DEPARTMENT FOR COMMUNITY SUSTAINABILITY

MEMORANDUM DATE: August 5, 2020

RE: 717 Lake Avenue

TITLE: <u>HRPB Project Number 20-0000014</u>: Consideration of a request for mural installation for the contributing structure located at **717 Lake Avenue**; PCN#38-43-44-21-15-019-0121. The subject property is located in the Downtown (DT) Zoning District and the Old Town Local Historic District.

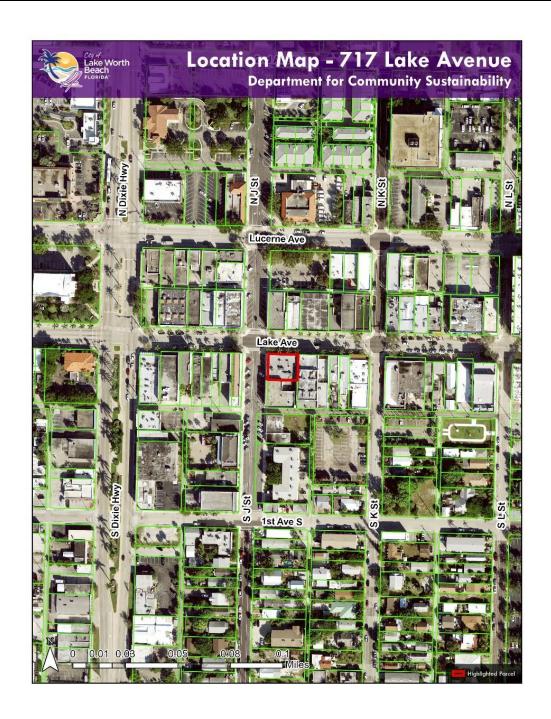
The Applicant, Adolfo Galvez, has submitted a request for a mural installation on the west elevation of 717 Lake Avenue facing South J Street. A portion of the mural will also front Lake Avenue on the north elevation of the structure. A general project description and a rendering of the proposed mural have been included in this report as **Attachment A**. Ruben Ubiera, a Miami-based artist, will complete the mural installation. The title of the mural is "Pancho Villa & the Day of the Dead." It seeks to highlight Pancho Villa, who was a general that played a crucial role during the Mexican Revolution (1910 to 1920). According to the artist, the mural will depict Pancho Villa enjoying his afterlife. In addition, the mural will utilize flowers and vivid colors to convey a friendly atmosphere. The subject property is located in the Downtown (DT) Zoning District and retains a Future Land Use (FLU) of Downtown Mixed Use (DMU).

- A portion of the mural will front Lake Avenue on the north elevation of the structure. A "calavera", which is representation of a human skull is featured on this portion of the mural. Murals fronting Lake Avenue may be allowed at the Board's discretion.

The west elevation of the structure, where the largest portion of the mural is proposed, is a secondary façade and is a historically appropriate location for a mural. Although sparse in architectural detailing, remaining character-defining features on this facade include vertical engaged columns and the recessed corner entryway. The mural, as proposed, generally does not obscure the engaged columns, but elements of the mural's design do partially overlap with the columns. Staff recommends that the mural be installed as depicted, so that the painting does not completely obscure these architectural elements that characterize the building.

- 1) This approval does not include any physical alterations to building's exteriors aside from paint application. No paint shall be applied to any windows, doors, shutters, or architectural elements not illustrated in the renderings. The engaged columns shall not be completely obscured by the mural, as illustrated in the renderings.
- 2) Prior to the mural being installed, the applicant shall apply for a City of Lake Worth Beach building permit.
